TOWN OF STOW ZONING BOARD OF APPEALS APPLICATION FOR:

Town of Stow
Randall Library Renovation + Addition
19 Crescent Street

The following project update is provided for the Randall Library Renovation and Addition Project located at 19 Crescent Street. Following the August 14, 2023 Special Permit and Site Plan Approval for the project, construction documents were finalized in preparation for bid in early October and bids were received in mid November. Unfortunately, the low bid that was received was considerably over budget. As a result, the project transitioned into a redesign process to consolidate scope and reduce costs.

As a result of the changes in both the building and site design, the following modifications to the special permit that was granted on August 14th, 2023 are requested:

Randall Library
Renovation + Addition
ZBA Application Materials
Attachment 5 - Proposed Site Plan
4/26/24

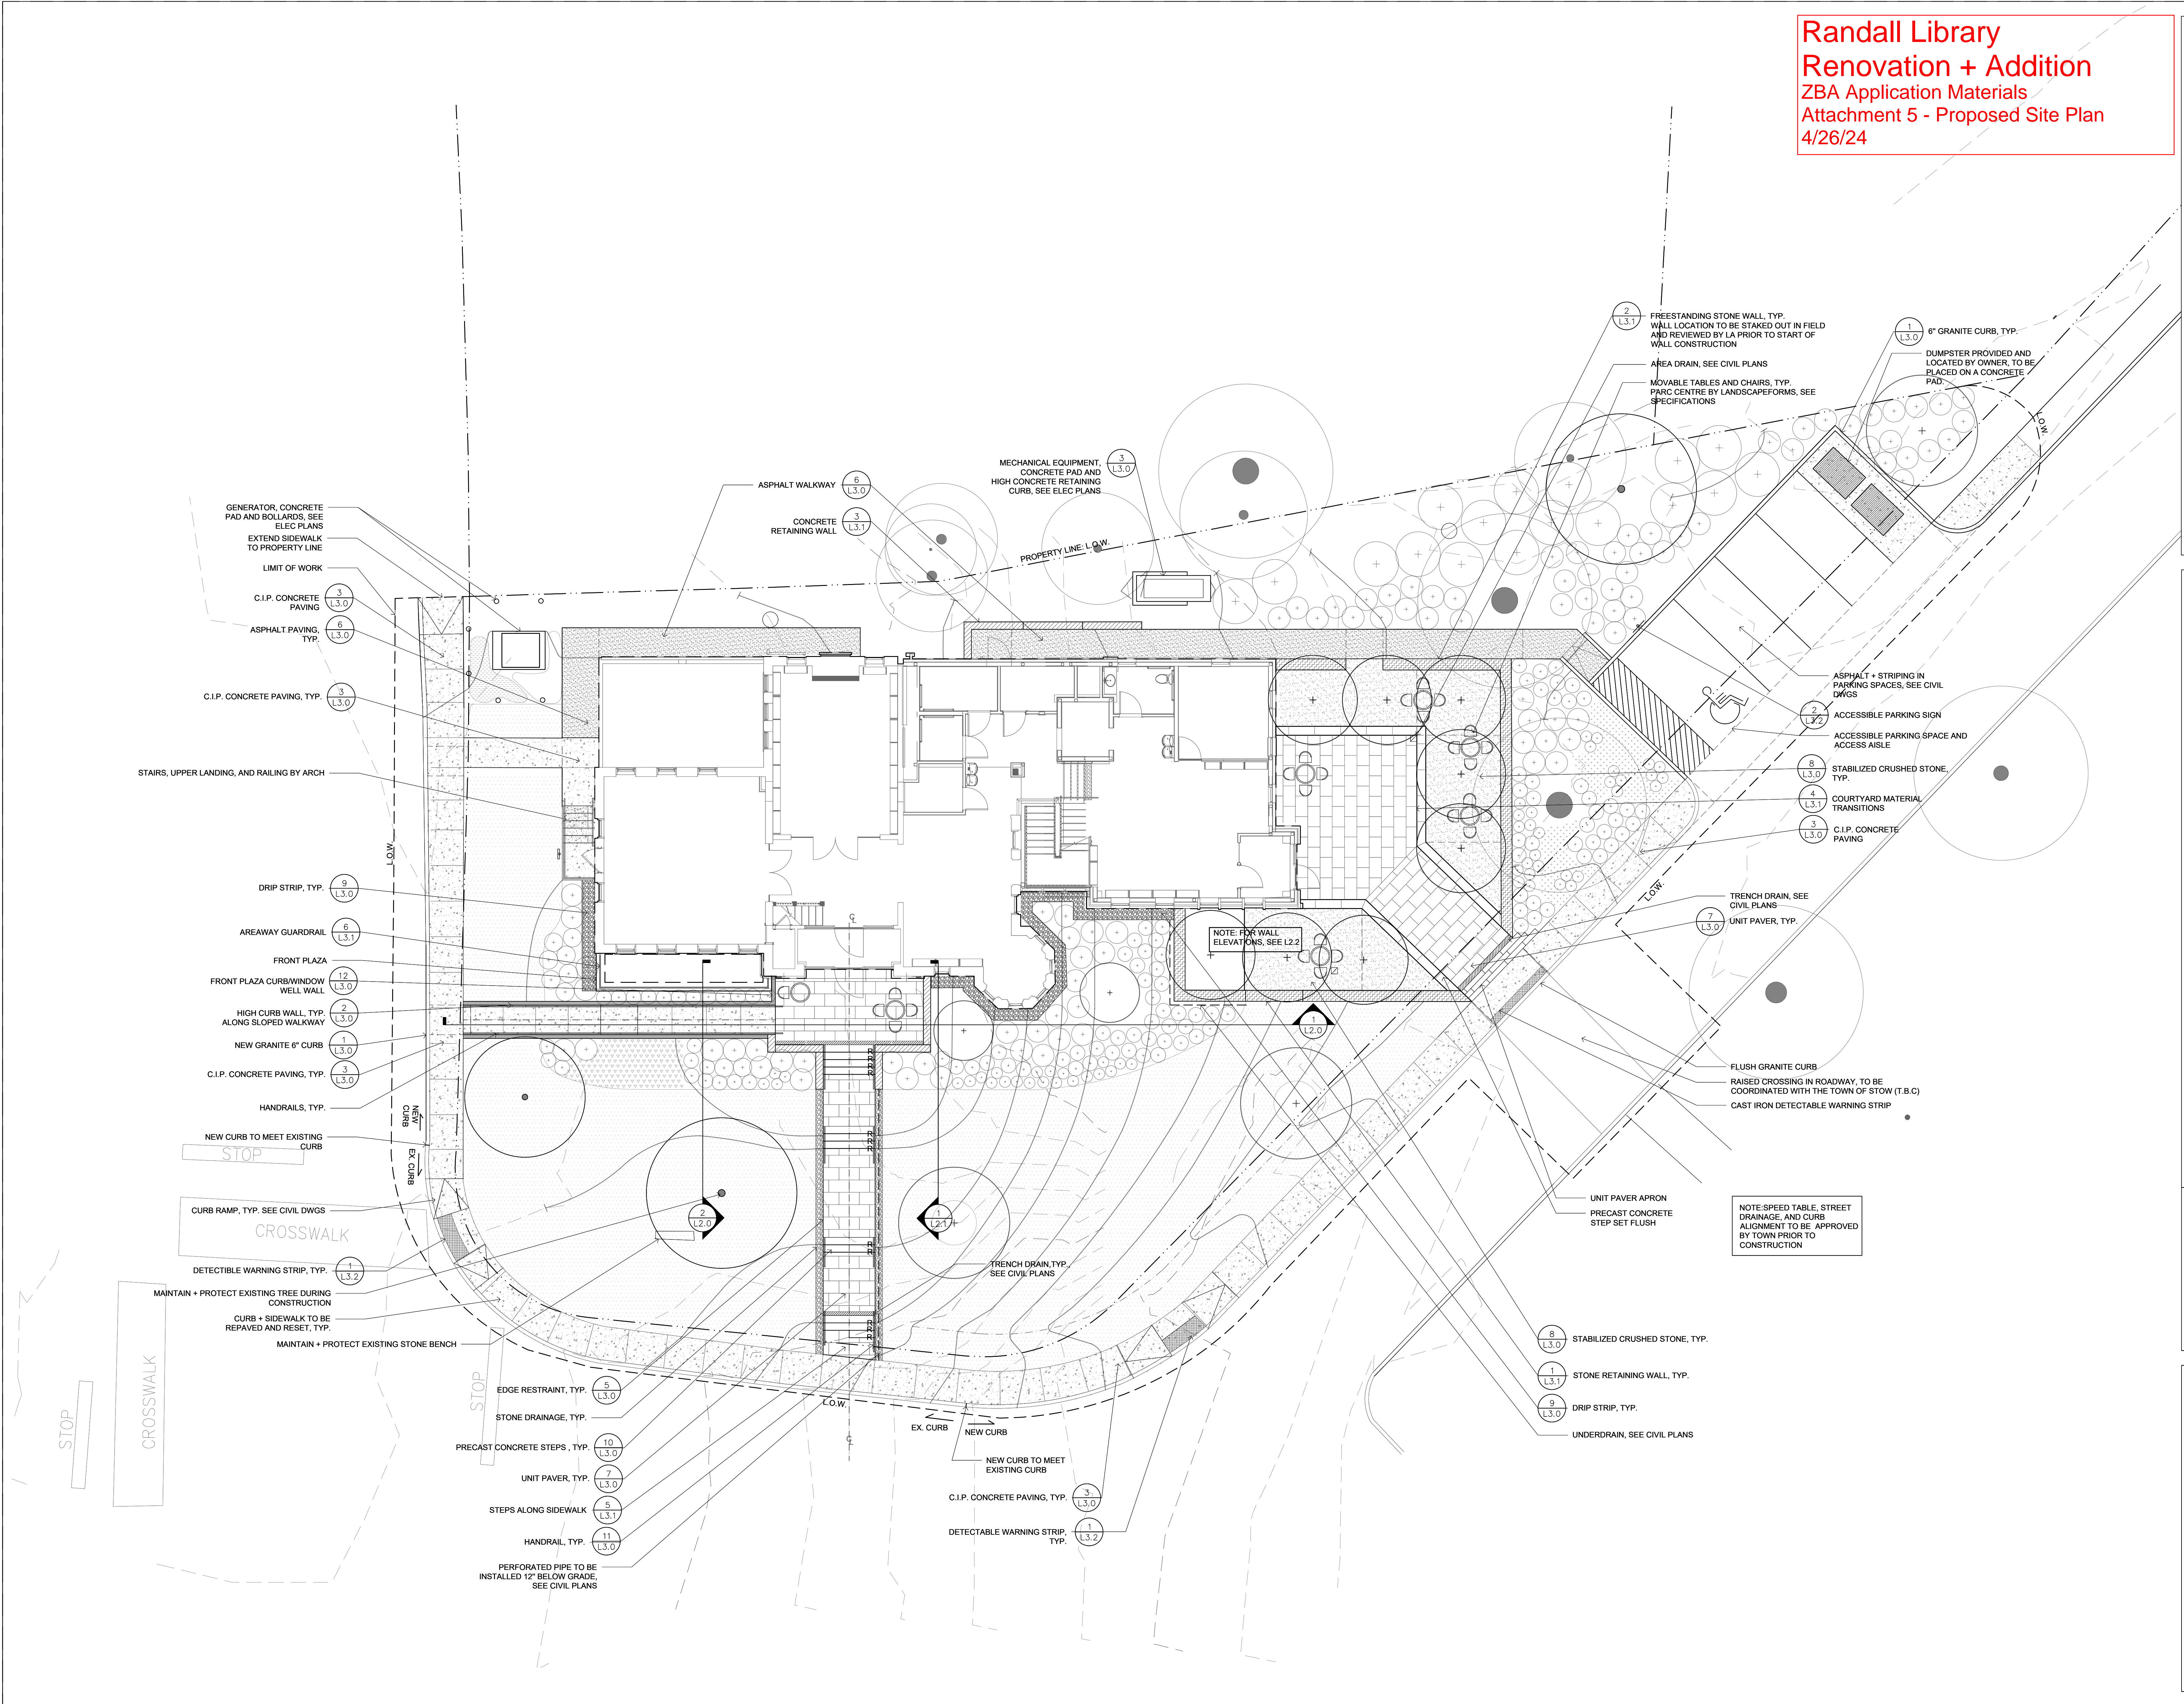
- Plantings (groundcover, shrubs, trees) have been simplified.
- Parking has been consolidated to be along Common Road (instead of Common Road and Crescent Street). The total parking provided along Common Road in the revised design is (1) ADA space and (3) regular spaces. This is a reduction in (1) ADA space and (1) regular space from the previous design. However, it is the project team's goal to reintroduce (1) ADA parking space along Crescent Street during the construction process if the project budget allows. However, this cannot be guaranteed at this time.

The revised proposed total square footage of the Randall Library is approximately 7,230 (reduced from the previous 8,700)

The revised footprint is approximately 3,710 (reduced from the previous 4,600)

Randall Library
Renovation + Addition
ZBA Application Materials
Attachment 6 - Proposed Utility Plan
4/26/24

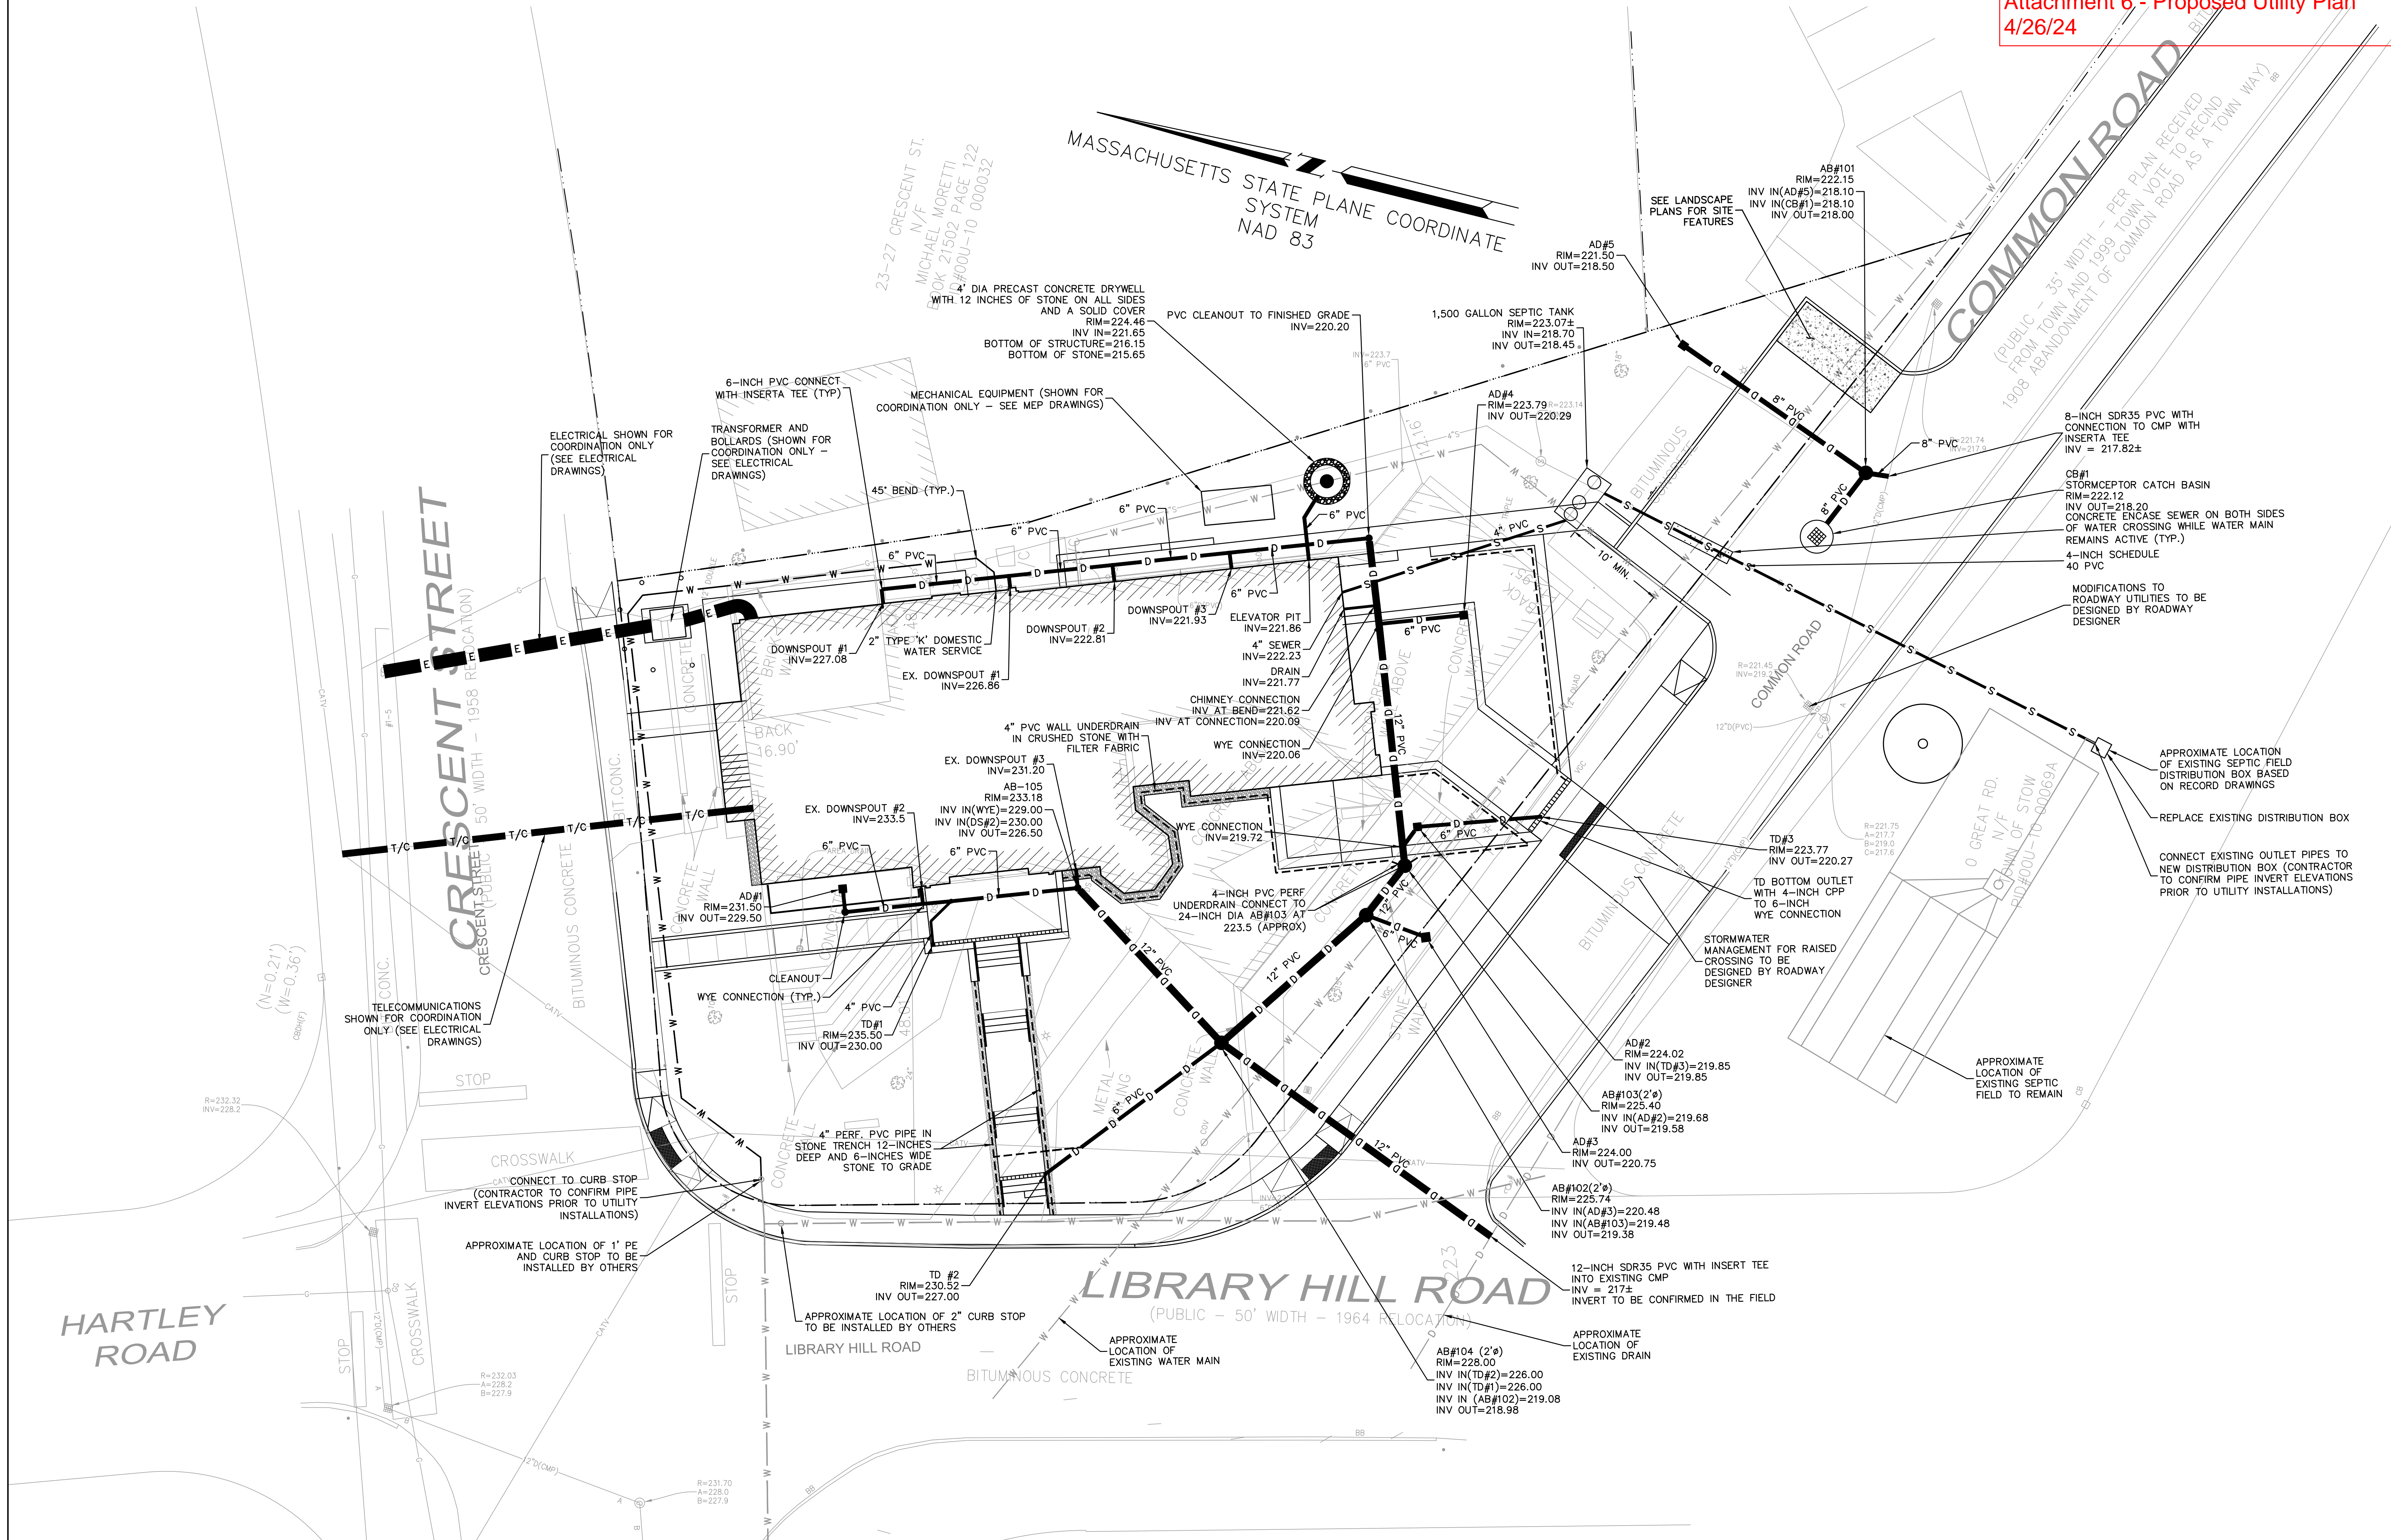
- The stormwater report has been updated to reflect the revised building and site design
- Erosion and stormwater control measures are included in the bid documents (drawings and specs published 3/29/24)
